FALCON SERVICE BULLETIN

FALCON 7X FALCON 8X

No 572

**PNEUMATIC
BLEED AIR LEAK DETECTION
CHECK OF PYLON BLEED AIR LEAK DETECTORS FOR
INTEGRITY**

Figure 2: USE OF HOT AIR GUN WITH NARROW BLOWER NOZZLE

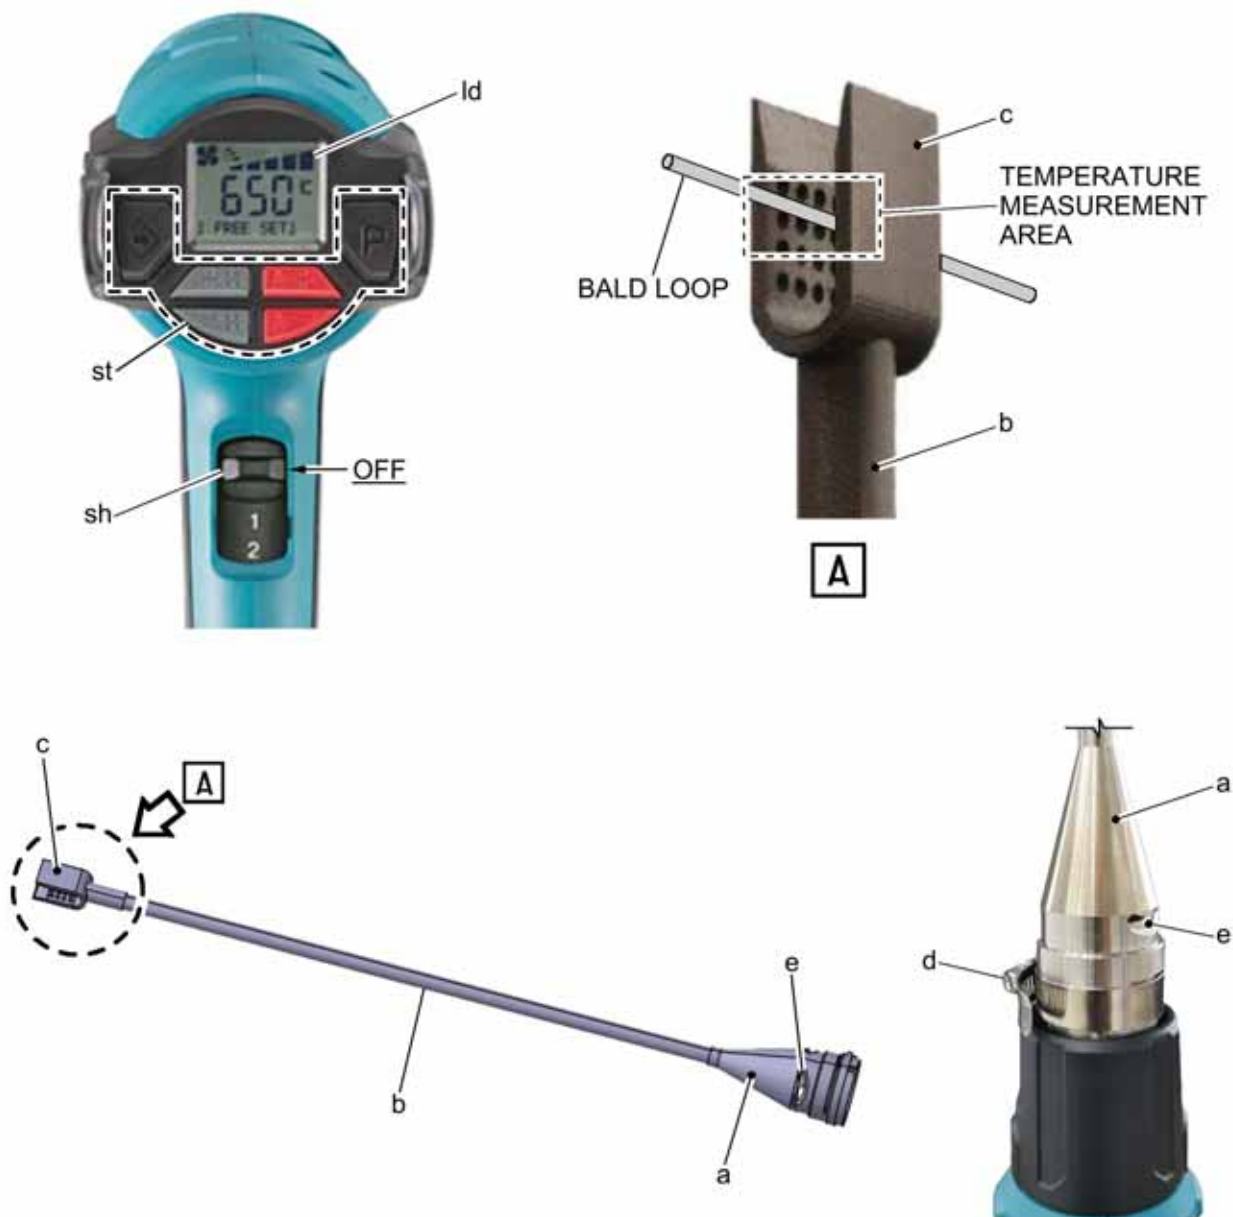
REASON: Modification of the test with the narrow blower nozzle.

- (7) Slide the switch (**sh-fig. 2**) of the hot air gun with the narrow blower nozzle (**c-fig. 2**) to position "2" to begin heating.
- (8) Adjust the temperature of the hot air gun with narrow blower nozzle as follows:

- (a) Set the ventilation to level 3.
 - (b) Set the hot air gun set point temperature to a minimum of 400°C (752°F), using the set of buttons (**st-fig. 2**) and LCD displays (**ld-fig. 2**) (refer to the instruction manual delivered with the tool case).

- (c) Using a digital thermometer, increase/decrease the set point temperature in 5°C (41°F) increments, until a temperature of 175°C (+9/-8°C) (347°F (+48.2/-46.4)°F) is measured at the middle of the blower nozzle.

NOTE: The temperature probe must be positioned at the center of the blower nozzle (**c-fig. 2**), as shown on **fig. 2**.

- LH upper loop (**L9203HU**), test point 3 (**fig. 3**),
- RH upper loop (**R9203HU**), test points 1 and 2 (**fig. 4**).

NOTE 1: For each point tested, the BALD loop must be as close as possible to the center of the nozzle airflow, as shown on **fig. 2**.

- (e) If the CAS message does not show before the 120 seconds time-out, remove the equipment to get access to the BALD loop area with the wide blower nozzle.

- (f) Test the point previously tested failed with hot air gun equipped with the wide blower nozzle by positioning the nozzle over the BALD loop using a heat shield to protect the surrounding equipment, if required.

- (g) If the CAS message still does not show after this new test, tag the failed BALD loop which will be replaced when all the other BALD loops have been tested (refer to step 2.D.).
